HISTORIC AND DESIGN REVIEW COMMISSION

Agenda Item No: 14

HDRC CASE NO: 2016-055
ADDRESS: 220 HERMINE BLVD
LEGAL DESCRIPTION: NCB 9008 BLK 4 LOT 39 THRU 43
ZONING: R4 H
CITY COUNCIL DIST.: 1
DISTRICT: Olmos Park Terrace Historic District
APPLICANT: Stevie Bear/Community REI LLC
OWNER: Austin Hedges/Community REI LLC
TYPE OF WORK: Install carport
REQUEST:

**Historic and Design Review Commission
Design Review Committee
Report & Recommendation**

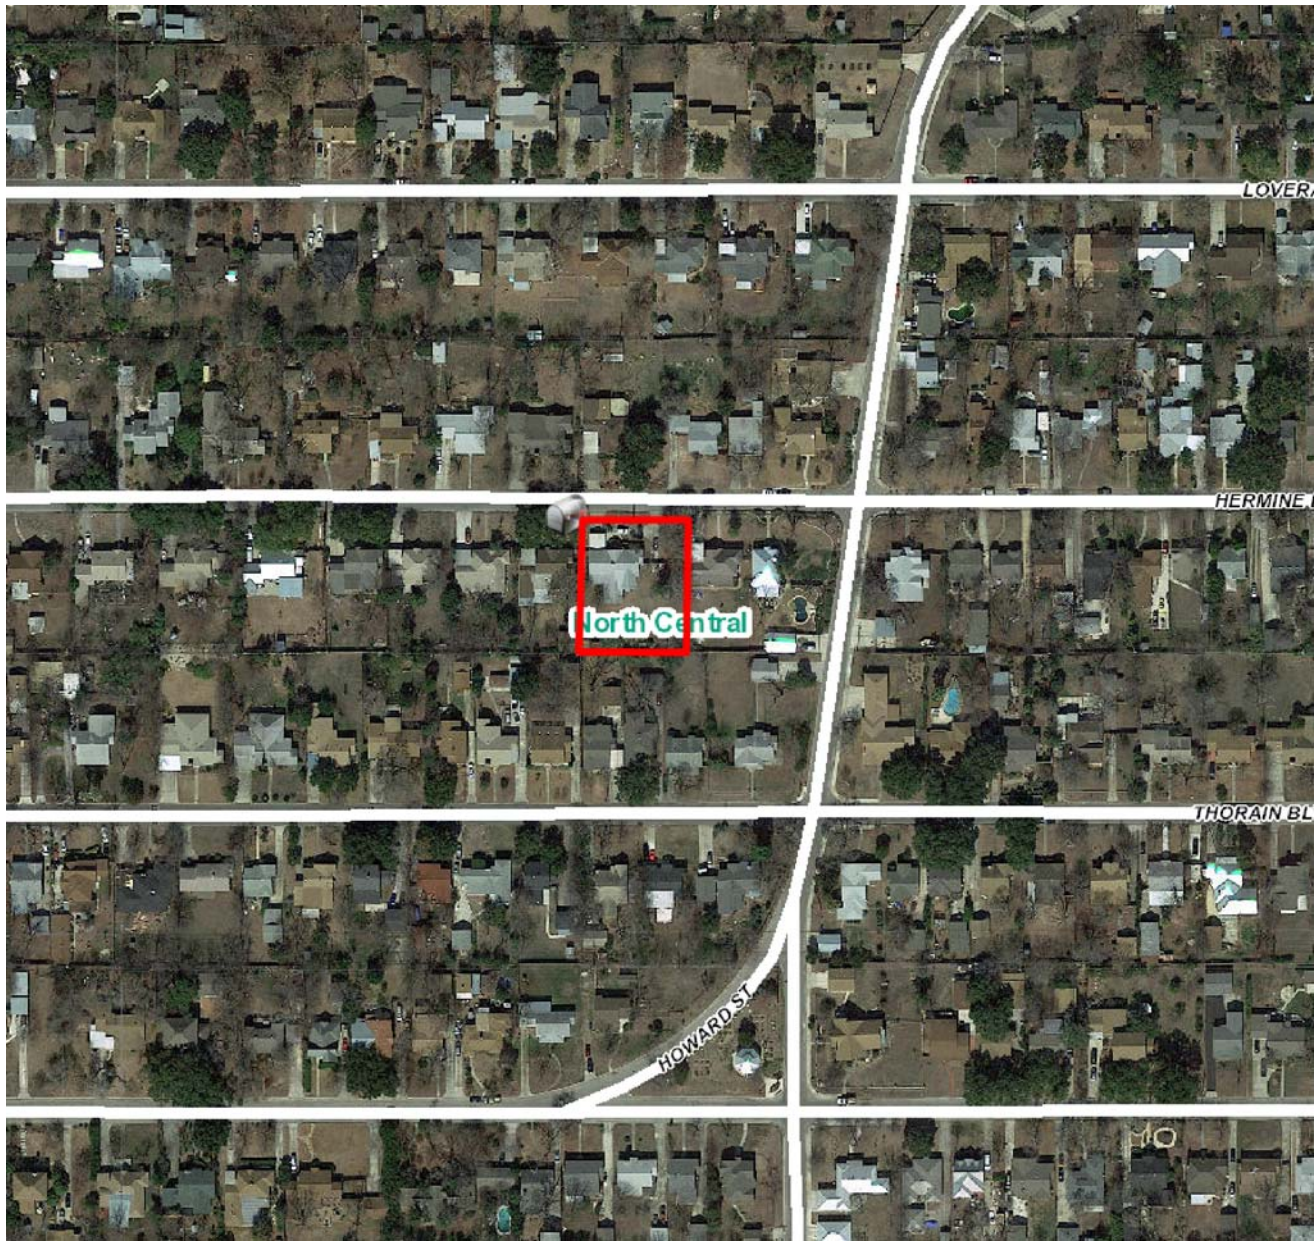
- d. The main structure at 220 W Hermine is a mid century house of modest size featuring one front gable and a shed roof over the front porch.
- e. The applicant is proposing to relocate the existing, 19'-8" x 20', pre-fabricated carport from in front of the garage onto the driveway to side of the east façade. The 10 metal posts will increase from 5' to 6' in height. The posts

will be squared with 1" x 6" boards and wrapped in a cedar veneer. Each of the 10 posts will be given a foot, by wrapping a 1" x 6" around the bottom.

- f. The applicant is also proposing to widen the left concrete driveway to accommodate the 19' wide carport. The driveway will gradually increase in width starting at the expansion joint, until it reaches 19' in width.
- g. According to the Guidelines for Exterior Maintenance and Alterations 9., new outbuildings should relate to the period of construction to the main structure. Staff made a site visit February 8, 2016, and found that carports are prominent on the street. Staff finds the placement of the carport appropriate; however, staff finds that a prefabricated carport structure is not appropriate for the historic structure's architecture style or the district. The applicant's proposal to locate the prefabricated carport structure to the side of the primary historic structure is not appropriate.

Staff does not recommend approval based on findings e through g.

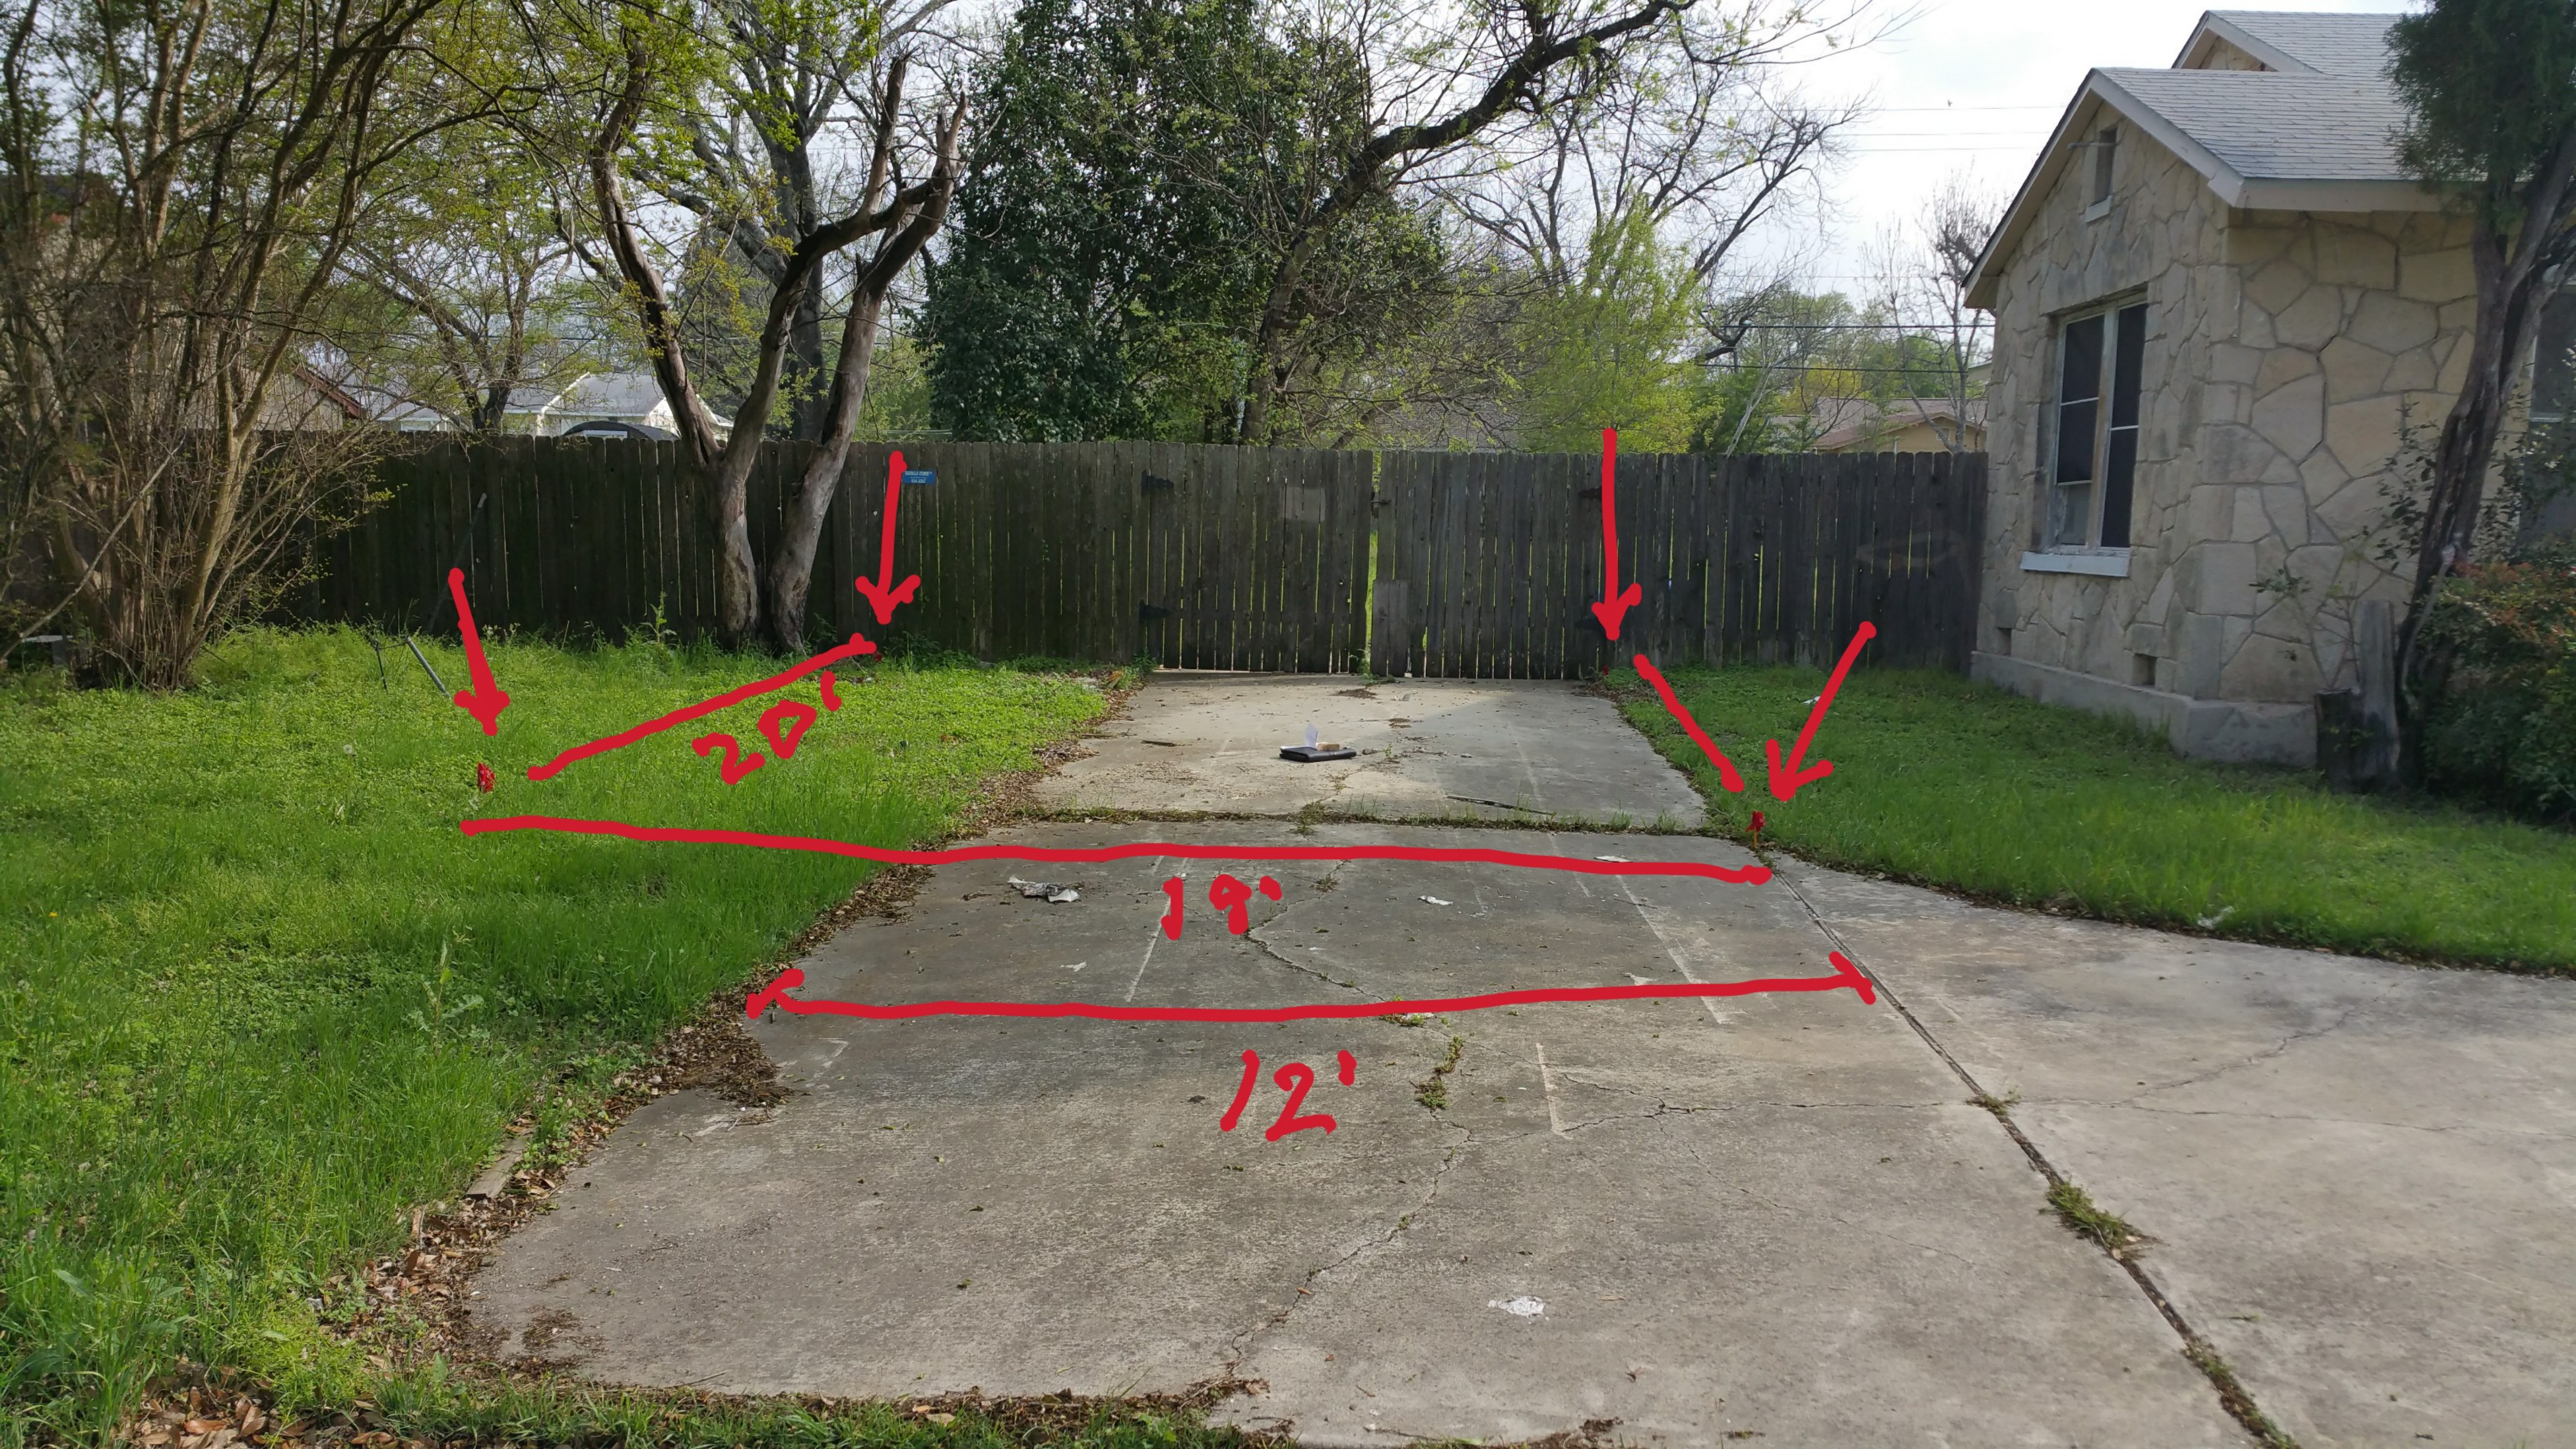
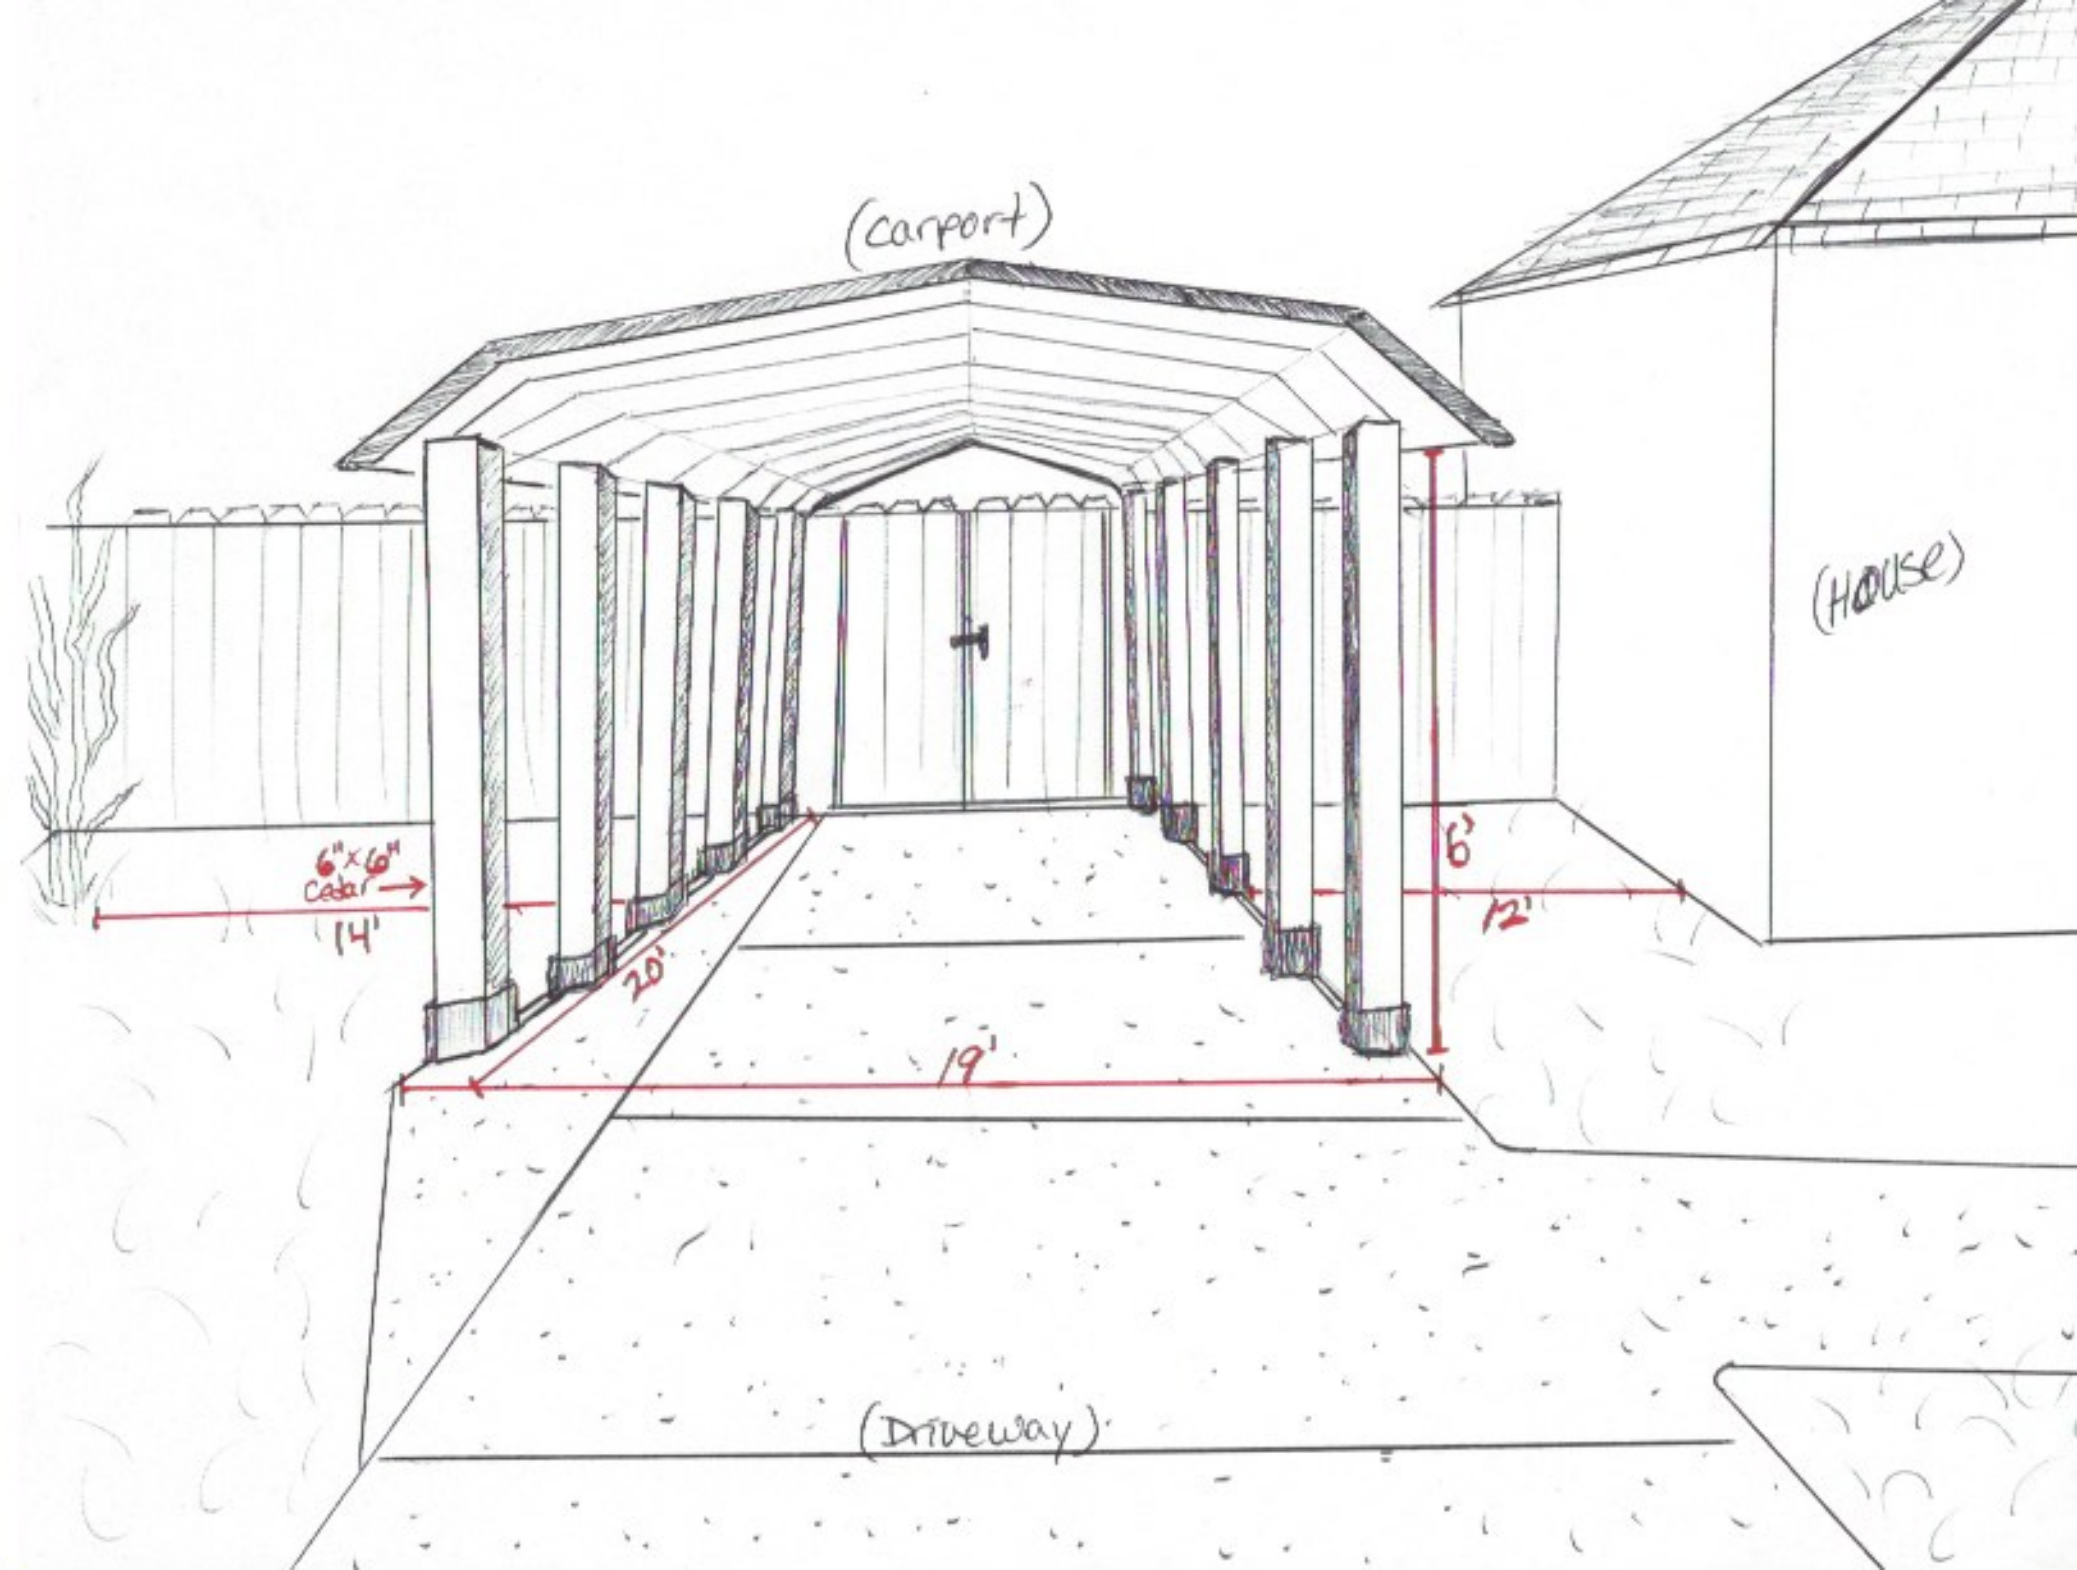
COMMENTS/CONCERNS: @ HDRC discussed moving back

BF: How would you increase height? How will
you install?

WAG: Are you pushing it back together?

BF: 1"x6" veneer appropriate
(How would you wrap cedar?)

metal Poles are 2"? How will end on the

ground? We don't want it to sit up? suggest on top

of board & put wooden/cedar base 6"x1" ~ foot.

Footing would look better

AG: would gate open?

BF: 6' dimension is at the pole?

AG: How would you pour concrete?

BF: suggest expand from ^{2nd} expansion joint and then rest at 20' / 20'

COMMITTEE RECOMMENDATION: APPROVE [☒] DISAPPROVE [☐]

as discussed
